MFN 08-780

Subject: Response to Portion of NRC Request for Additional Information Letter  
No. 208 - Related To NEDE-33338P, "ESBWR Feedwater  
Temperature Operating Domain For Transient And Accident Analysis"  
– RAI Number 4.3-24

**Enclosure 1**

**RAI Number 4.3-24**

# Heat Balance at FW Operating Point SP1M

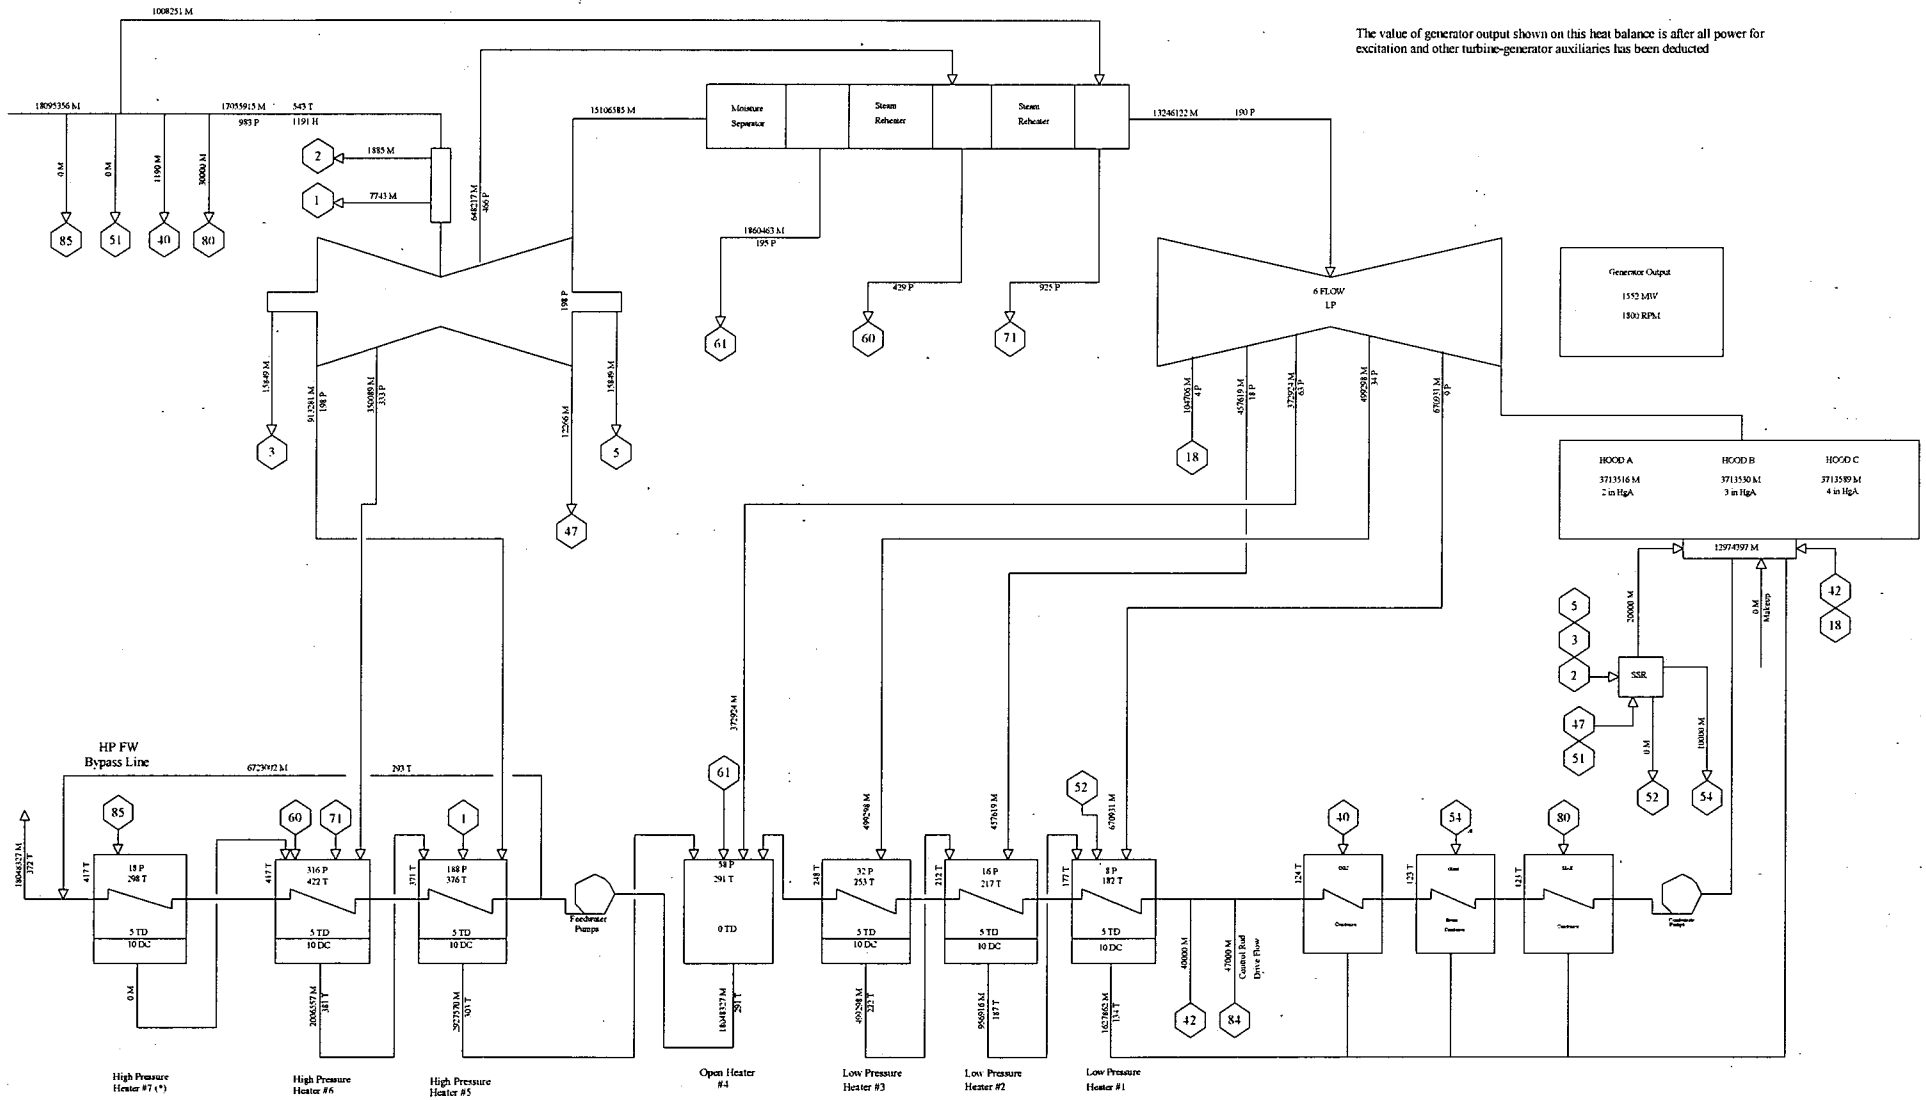
*For operating points SP1M and SP2, provide a heat balance sheet similar to the one in Figure 10.1-2 of DCD Chapter 10.*

GEH has evaluated the heat balance conditions at the two points identified in the Feedwater Temperature Operating domain – points SP1M and SP2. The associated heat balance diagrams are attached.
